ADDENDUM NUMBER 02 TO THE BID DOCUMENTS

**BID DOCUMENT: 17/18 MB7
I21-35617 - Organic Farm Classrooms
College of Marin – Indian Valley Campus**

Addendum Date: 23 February 2018

SHEET NO:
E1.01

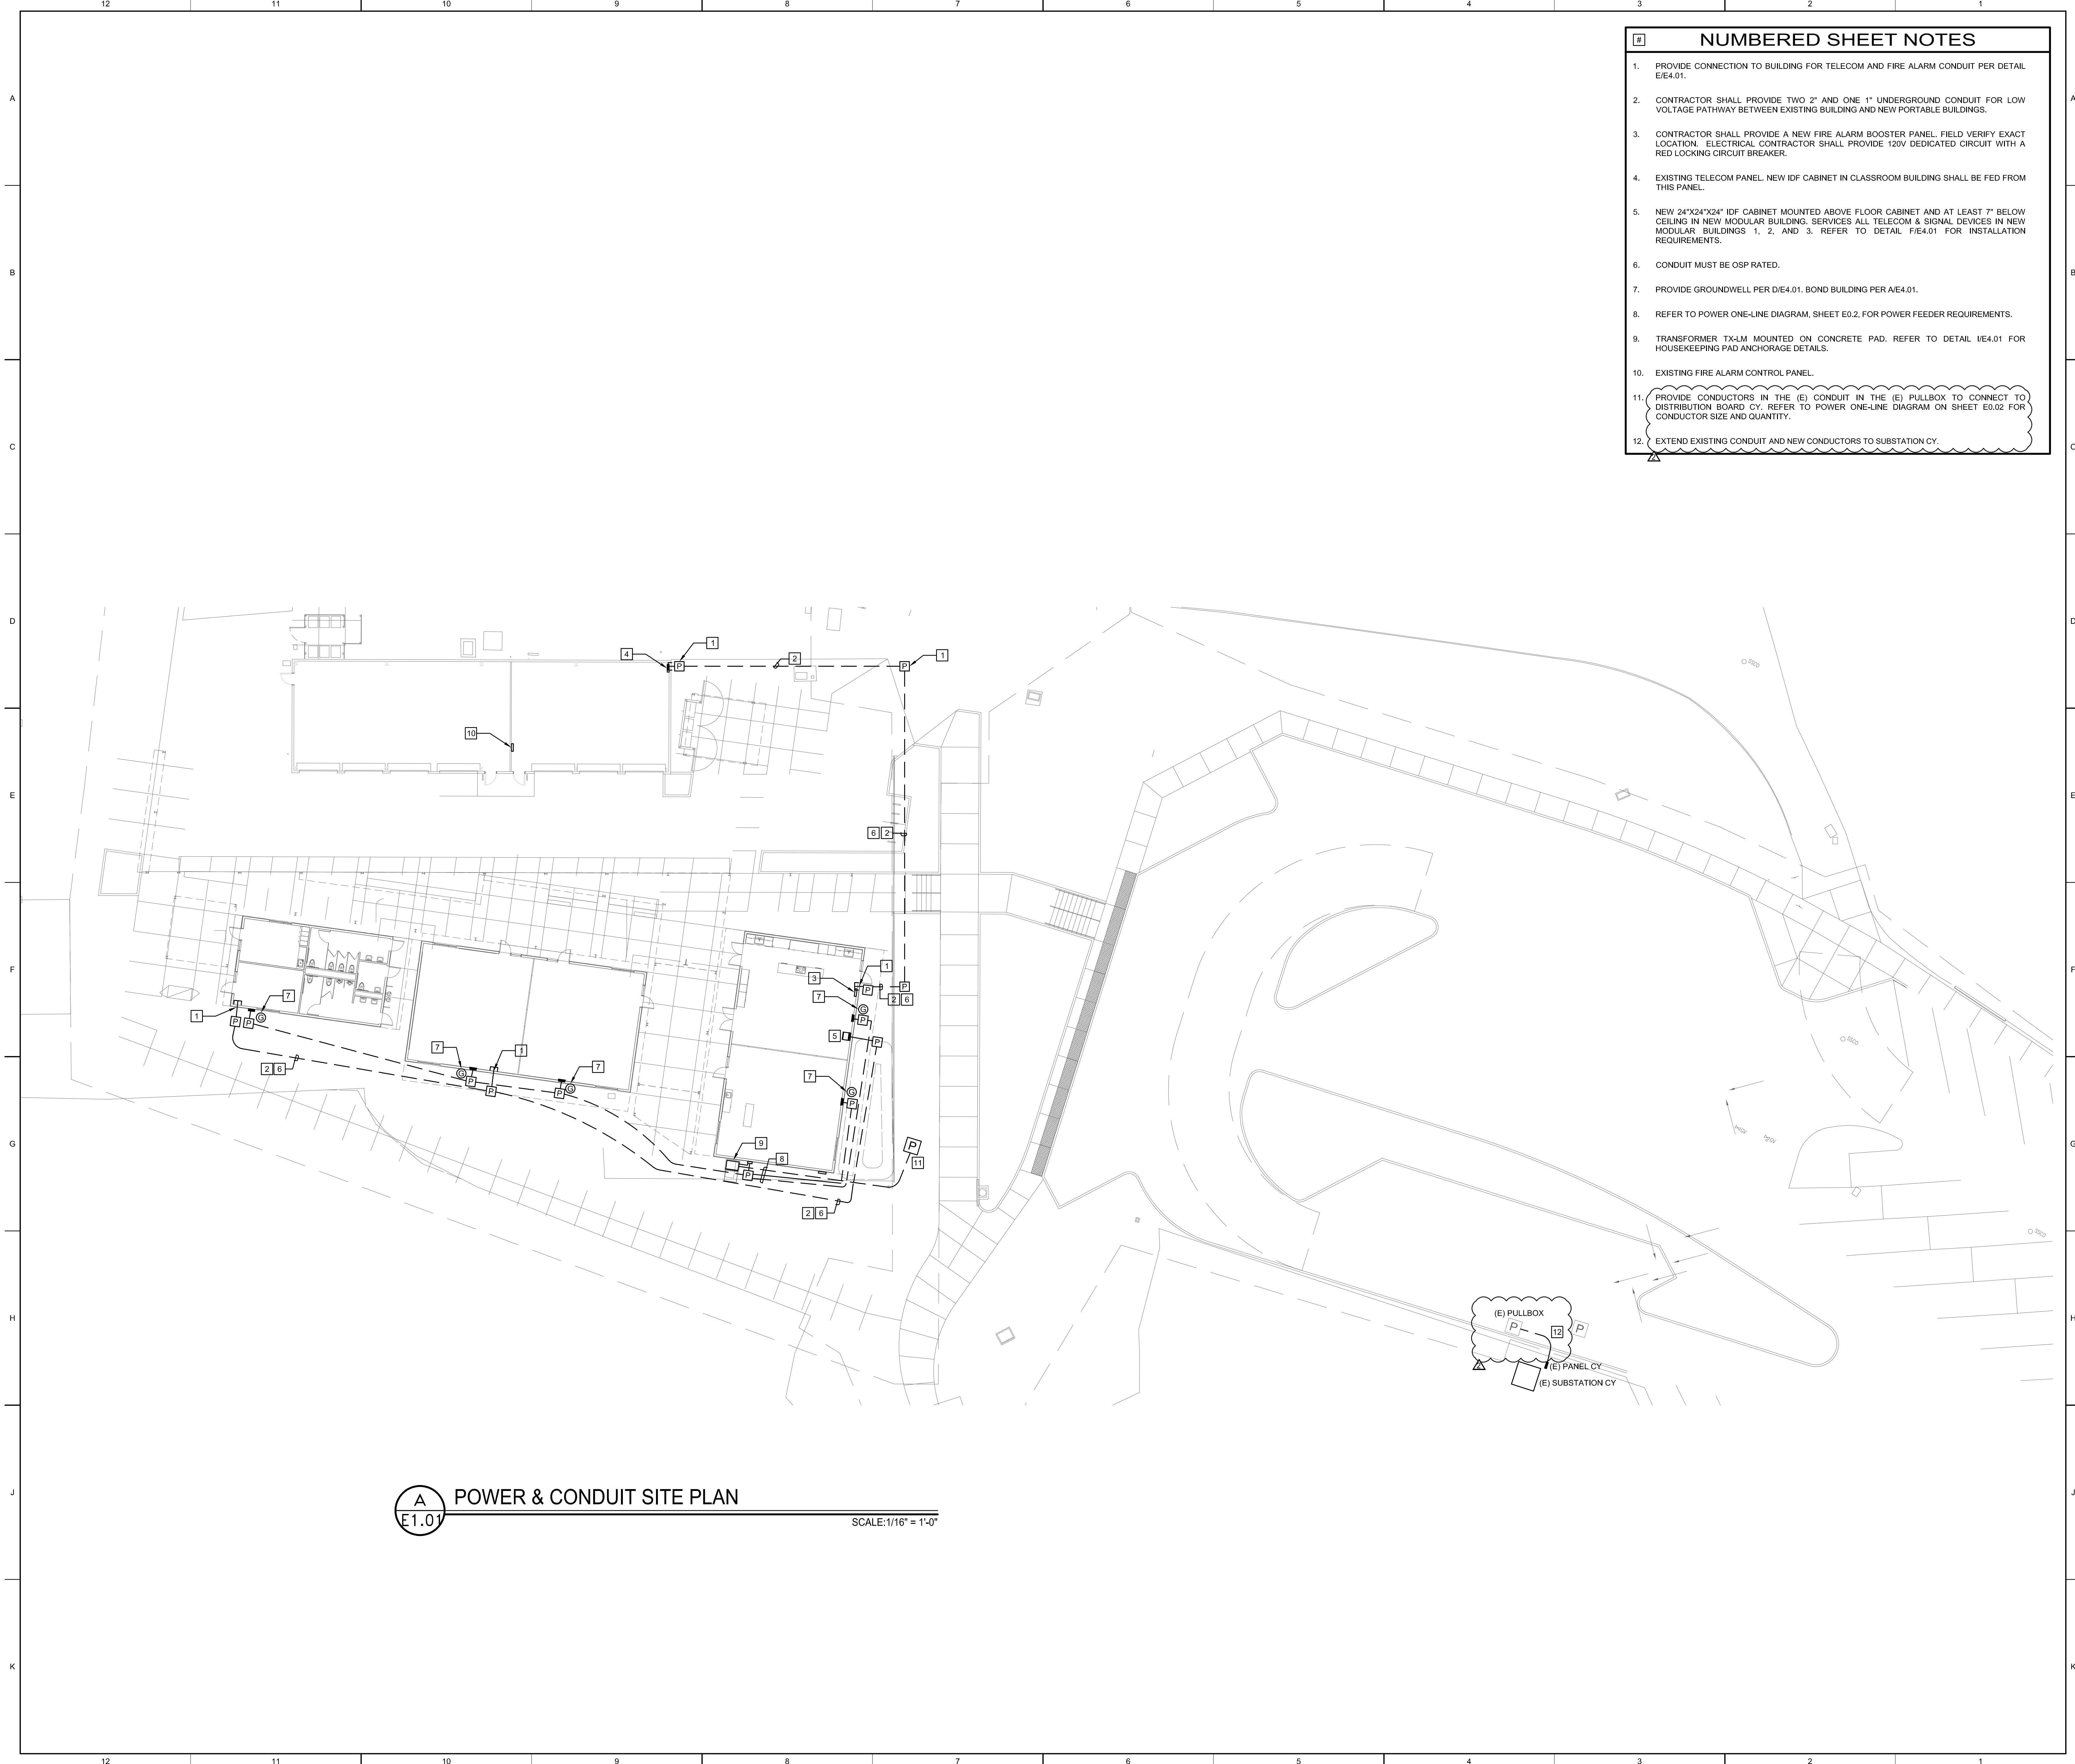
- Run power to the existing parking lot substation through existing conduit.

12. EXTEND EXISTING CONDUIT AND NEW CONDUCTORS TO SUBSTATION CY.

L2.00

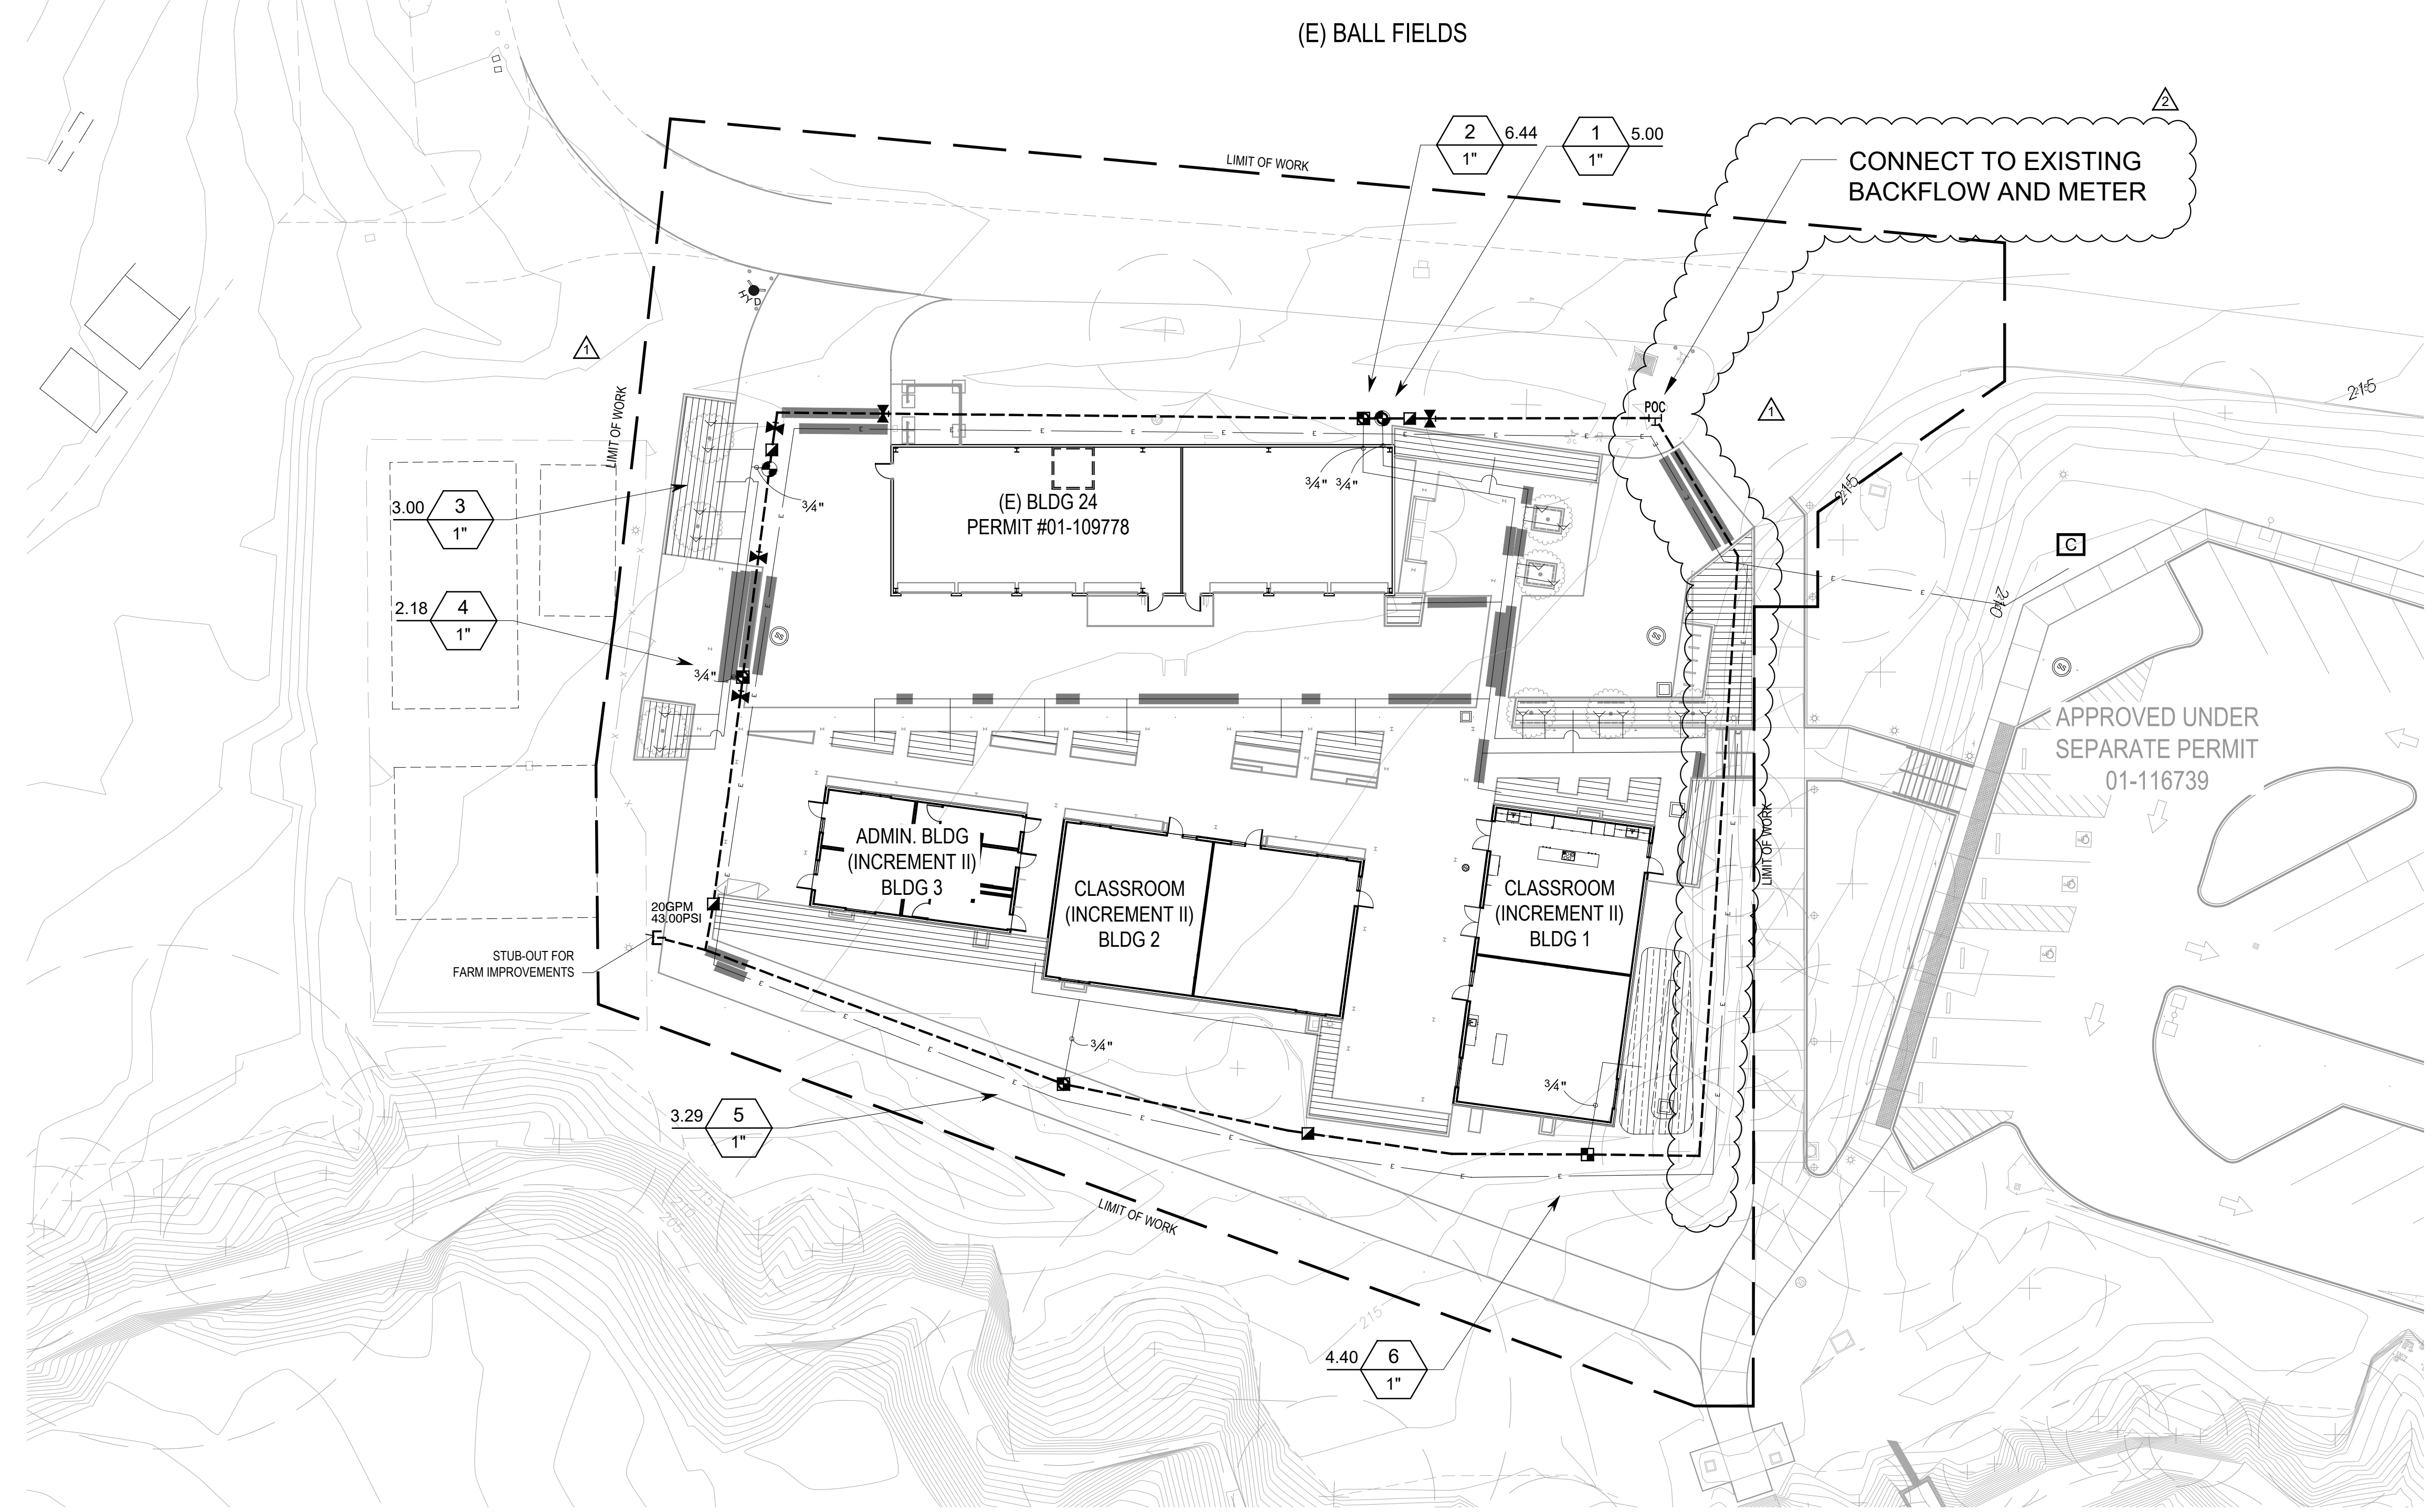
- Point of connection to be at the existing backflow.
- Updated calculations based on point of connection.

FLOW AVAILABLE	
Point of Connection Size:	2"
Flow Available:	78.62 gpm
DESIGN ANALYSIS	
Maximum Station Flow:	15.28 gpm
Flow Available at POC:	78.62 gpm
Residual Flow Available:	63.34 gpm
PRESSURE AVAILABLE	
Static Pressure at POC:	44.00 psi
Friction Loss:	3.03 psi
Loss through backflow:	13.44 psi
Residual Pressure Available:	27.53 psi
